TEJON-CASTAC
WATER
DISTRICT

South of Kern River Executive Committee Regular Meeting

Thursday, October 10, 2024

**Re: Comments on the Kern County Subbasin Probationary Hearing Draft Staff Report
Kern County Subbasin 2024 Groundwater Sustainability Plan
Kern County, CA**

Figure 1. Distribution of Groundwater Elevation Range Within a 2-mile Radius of Each RMW.

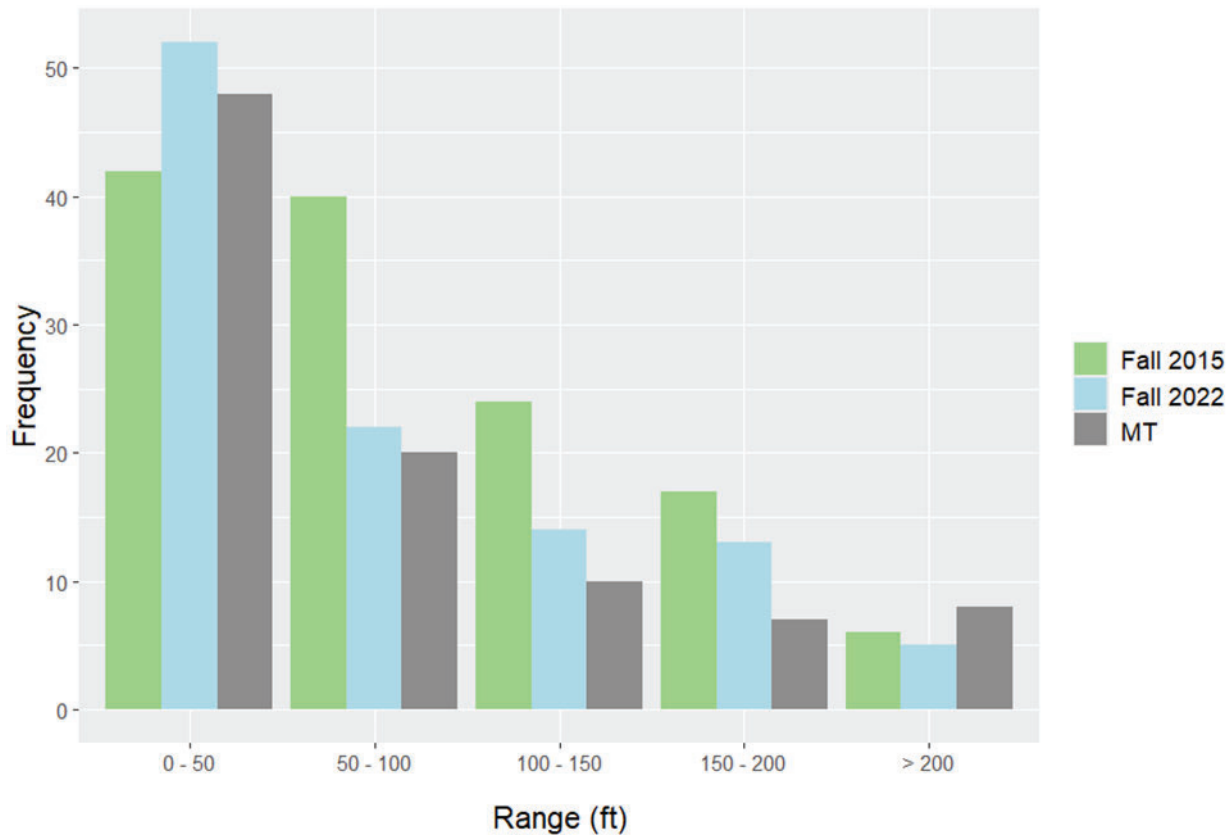
In response to Board Staff’s comment that “groundwater level MTs vary dramatically across hydrologic areas” we conducted an analysis of the spatial variability of measured water levels across the Subbasin in 2015 and 2022 as compared to the spatial variability of the MT values. Specifically, the range in groundwater elevation measured at RMWs located within a 2-mile radius of each RMW was calculated. The histogram in **Figure 1** shows the distribution of the observed range in water levels within the 2-mile radius of each RMW for historical groundwater elevation data (Fall 2015 and Fall 2022) as compared to the observed range in the MT values.

The histogram in **Figure 1** shows that the MT values have similar total ranges compared to observed water level data across the Subbasin, reinforcing that the differences in MT values seen in neighboring RMWs accurately reflect local conditions. The observed ranges in MT values are therefore not an inhibitor to sustainable groundwater management, but rather reflect the very real influence of geologic features (faults, synclines, anticlines), topographic changes, and operational variability on water level conditions throughout the Subbasin.

Figure 2. Locations of RMWs with “Outlier Trends” (Mean \pm 1 Standard Deviation).

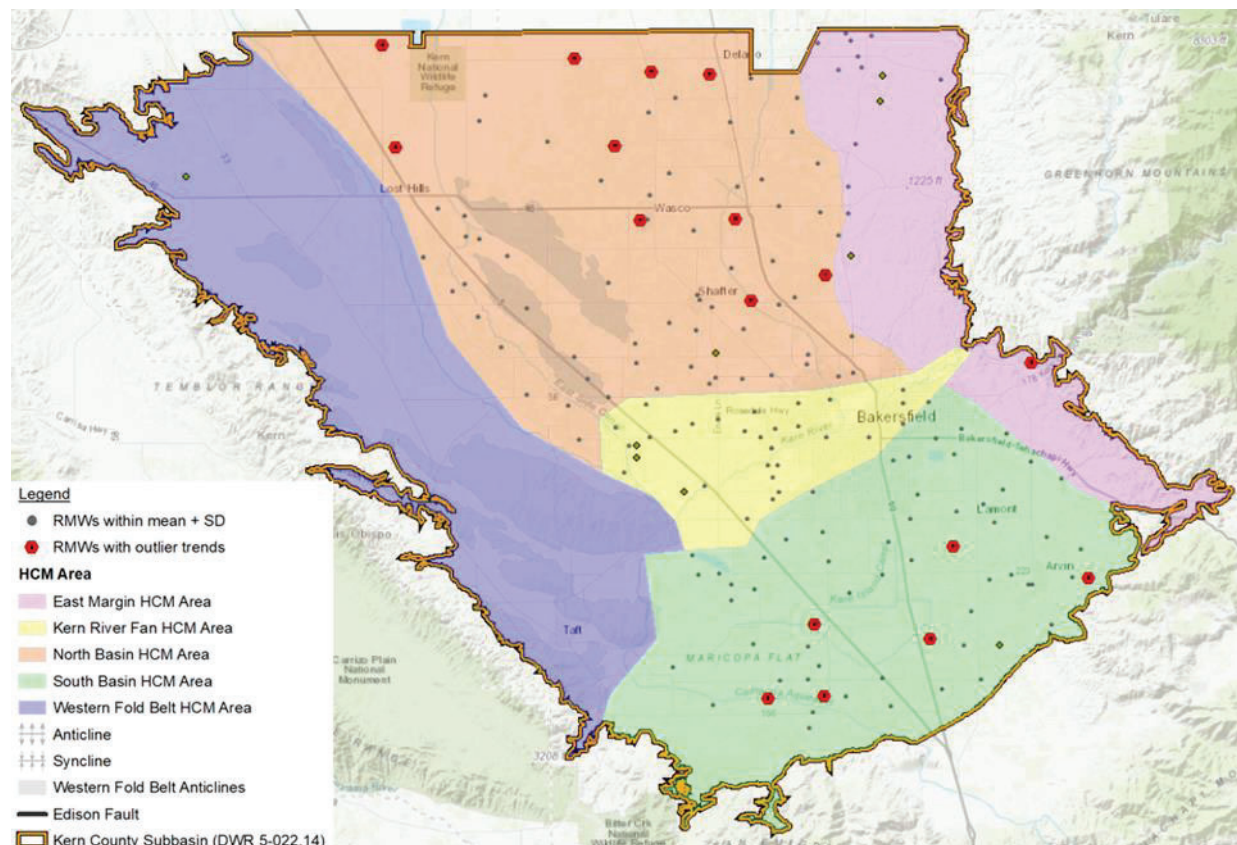
In response to Board Staff’s comment that “regionally-averaged declining elevation trends ... may have resulted in a skewed (heavily weighted toward areas of more pumping and lower elevation) approach in setting MTs” we have mapped the location of those RMWs that have “outlier trends” (i.e., a historical trend value that is more than ± 1 standard deviation). As shown on **Figure 2**, these handful of RMWs are spatially distributed across the Subbasin, are not clustered together, and only potentially impact two of the HCM areas.

Figure 4. Analysis of Time vs. Affected Area Outside the Kern Water Bank Exceeding 5 feet Up or Down Compared to Without Project Conditions.

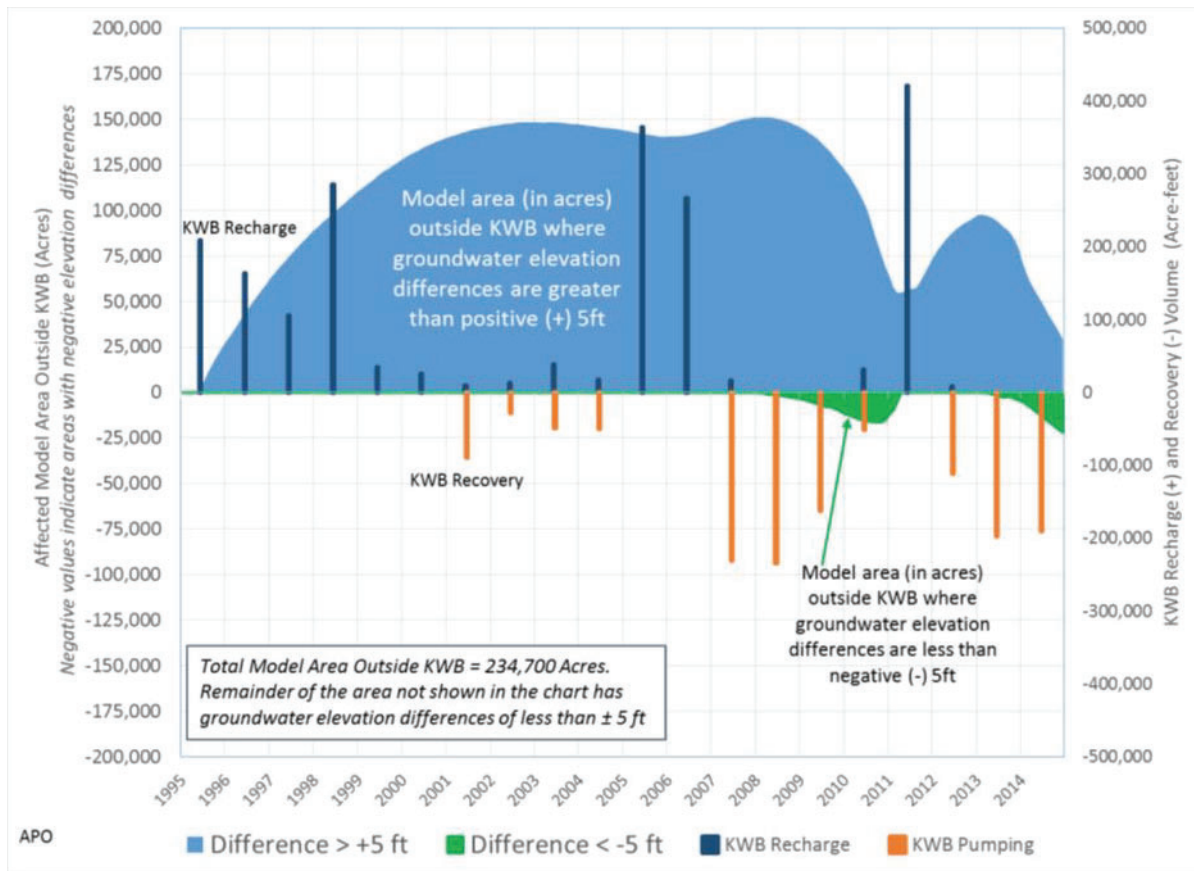
The following comment regarding the water banking programs described in Appendix E of the 2024 Plan was made in the draft Staff Report: "*Plans lack clarity on banking operations and how they impact the ability of the basin to avoid hitting MTs. This is especially true given that the GSPs' Appendix E, Kern Fan Water Banking Program, stated that, "[t]he Projects cannot cause chronic lowering of groundwater levels or a reduction in storage"* (2024 Draft Main GSP, Appendix E. p. 7) (Groundwater Level deficiency)." (Draft Staff Report, p. 192.)

A response to this comment was provided in the companion letter (**Appendix A.2**, Page A7-9) and is included here by reference. That response included the figure shown below which was developed by DWR during a review of Kern Water Bank (KWB) operations from 1995 through 2014.

Figure 4 illustrates the area in acres outside the KWB where water levels exceeded 5 feet either up or down as compared to the without project condition resulting from KWB operations for the period from 1995 through 2014. As shown, groundwater levels for significant areas outside the KWB were higher than 5 feet throughout the entire period as a result of KWB operations. Groundwater levels were lower than 5 feet for some areas for limited times toward the end of significant droughts when large volumes of banked groundwater were recovered to compensate for limited supplies of surface water. Thus, a lowering of groundwater levels is not indicated for most of the adjoining areas for the 1995-2014 period.

Figure 1. Water level transect along cross section E-E' comparing Fall 2015, MO, and MT groundwater elevations.

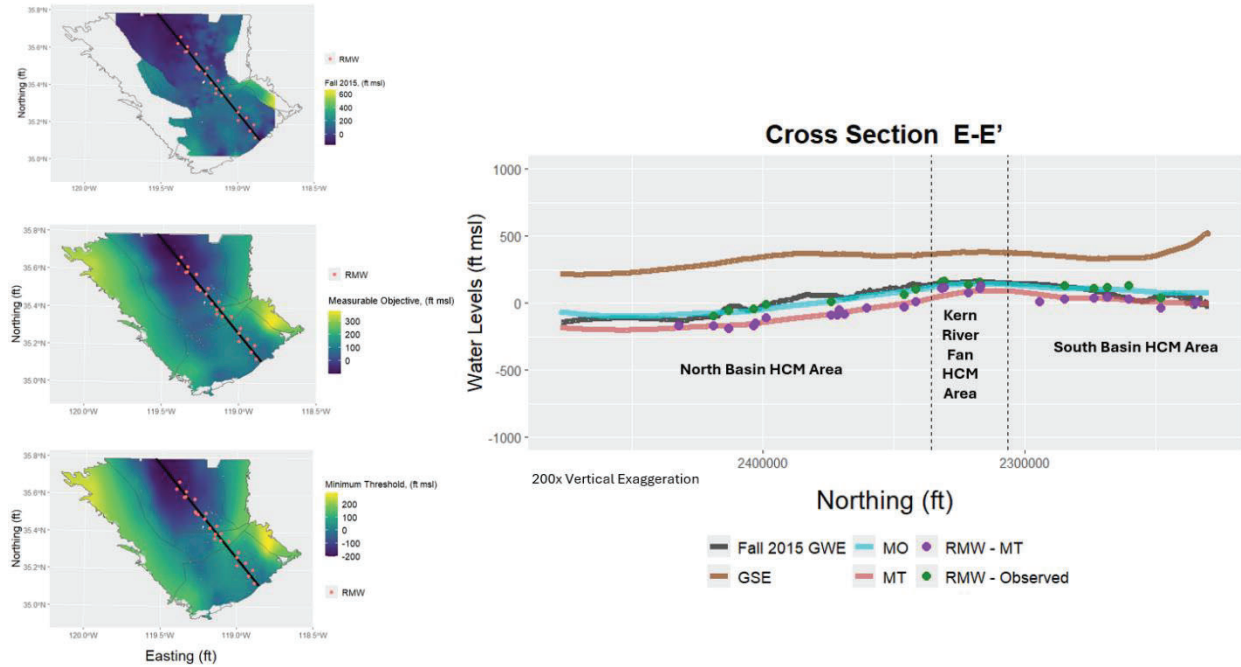
The SWRCB Draft Staff Report states that the “groundwater level MTs ... vary dramatically across ‘hydrological areas’ of the subbasin”. As shown in the contour maps and the three transects Figure 1, Figure 2, and Figure 3 below, the MT (and MO) values in fact do not “vary dramatically” between HCM Areas. They instead appropriately reflect the localized water level conditions across the Subbasin similar to those observed in Fall 2015. Similarly, spatial interpolations of the MTs and MOs at RMWs are similar to the Fall 2015 water level spatial interpolation. It should be noted

that the transects show smooth MT and MO interpolated values, and some of the apparent discrepancy at the RMW points is related to the translation across up to a two-mile distance to the transect lines.

Figure 4. Cross section A-A' comparing showing distribution of clays along the Kern River Fan.

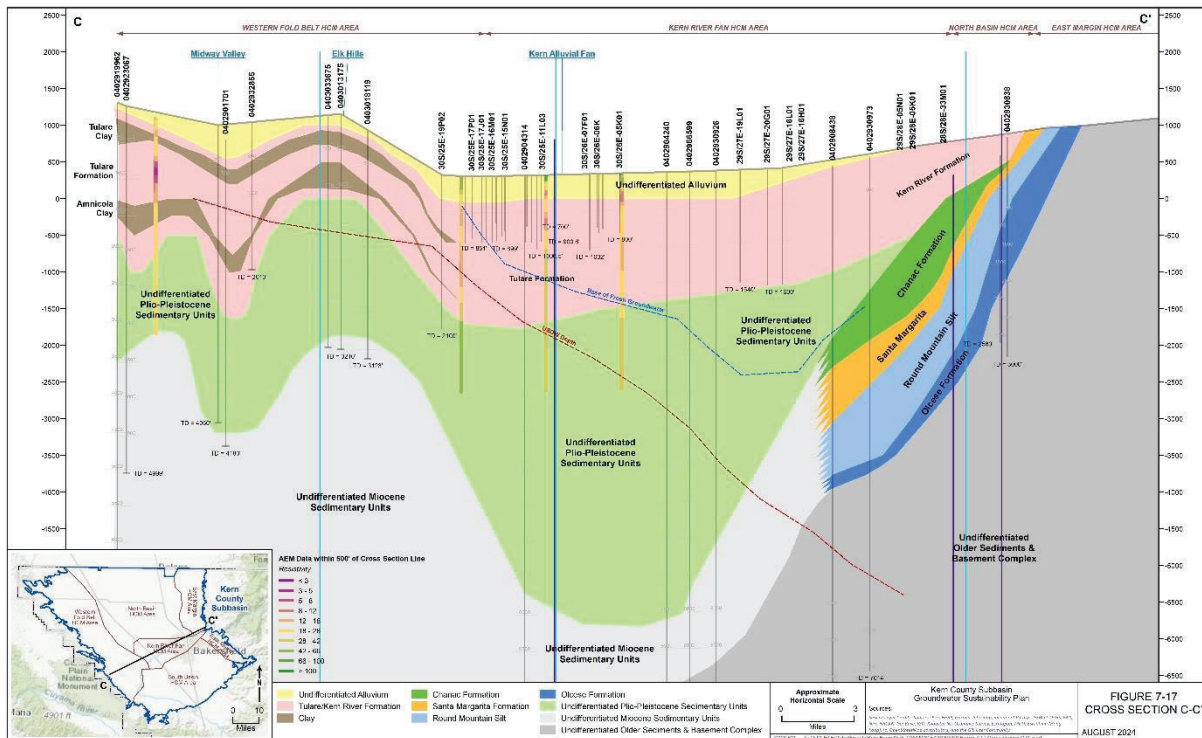
- *The GSAs do not demonstrate a fundamental understanding of the Subbasin’s settings. For example, monitoring well networks for groundwater levels and groundwater quality do not differentiate between confined and unconfined aquifers separated by the E-clay (a confining layer), or other clay layers. Most monitoring wells appear to be screened in the confined aquifer, and therefore may not be protective of all beneficial users when water levels in the unconfined aquifer are lower than that in the confined aquifer. An understanding of groundwater levels and groundwater quality in the unconfined and confined aquifers, as well as subsidence and groundwater quality, is essential for characterizing hydrogeologic conditions throughout the subbasin. Well impact analyses, monitoring plans, or mitigation strategies developed without this knowledge are insufficient and may not be protective of beneficial*

For the 2024 Plan, the alluvium was defined as a single principal aquifer rather than subdividing it into upper and lower principal aquifers based on the actual mapping and analysis of the extent and thickness of the E-Clay. Figure 4 illustrates the lack of E-Clay along the Kern River Fan area. Utilizing maps of the E-Clay extent from the USGS and others (Croft 1972, Page 1983, 1986; PGA 1991), it was determined that the E-Clay is absent in over 60% of the Subbasin. In another 30%, the E-Clay is either discontinuous or near the margins, where zones above and below it are hydraulically connected (see Figure 7-24 of the 2024 Plan). Thus, given the limited and discontinuous nature of the E-clay, the aquifer system functions as a single principal aquifer with some local zonation influenced by the E-Clay and other clay layers (see Sections 7.2, 7.3 and 7.4), and was appropriately defined as such.

The variability of the E-Clay justifies establishing a single principal aquifer for the alluvial sediments. This is based on a fundamentally sound understanding of the Subbasin-wide hydrogeology. As an example of the hydraulic relationship along the northern fringe of the Subbasin, Figure 5 on the following page shows a series of hydrographs and land subsidence of nearby wells for four areas along Highway 99. The Delano Municipal Airport (Site A) is the furthest northern site within 2 miles of the boundary with the Tule Subbasin and shows examples of zonation among three aquifer zones at variable depth by location. The Highway 99 at Kimberlina Road (Site D) is the farthest southern location and only about 13 miles south of the Delano Airport. At the Delano Municipal Airport site, the groundwater elevations in the shallowest screened zone are higher than the lower zone at times but are nearly the same at other times. This relationship indicates the effects of local zonation as evidenced by increased subsidence at Site A compared to the other three sites that have similar groundwater elevations over the period of record. At the three more southern locations, the difference between the shallower and deeper screened intervals is minimal indicating little to no local zonation in these areas. The smaller magnitude of subsidence observed at the three southern sites compared to Site A is because the E-Clay and lesser clay layers diminish to the south (Figure 4). These wells provide an example of the observed hydraulic response observed in the Subbasin near the Friant-Kern Canal. While localized vertical head differences are present in some areas of the Subbasin, the alluvial aquifer at the Subbasin-scale is
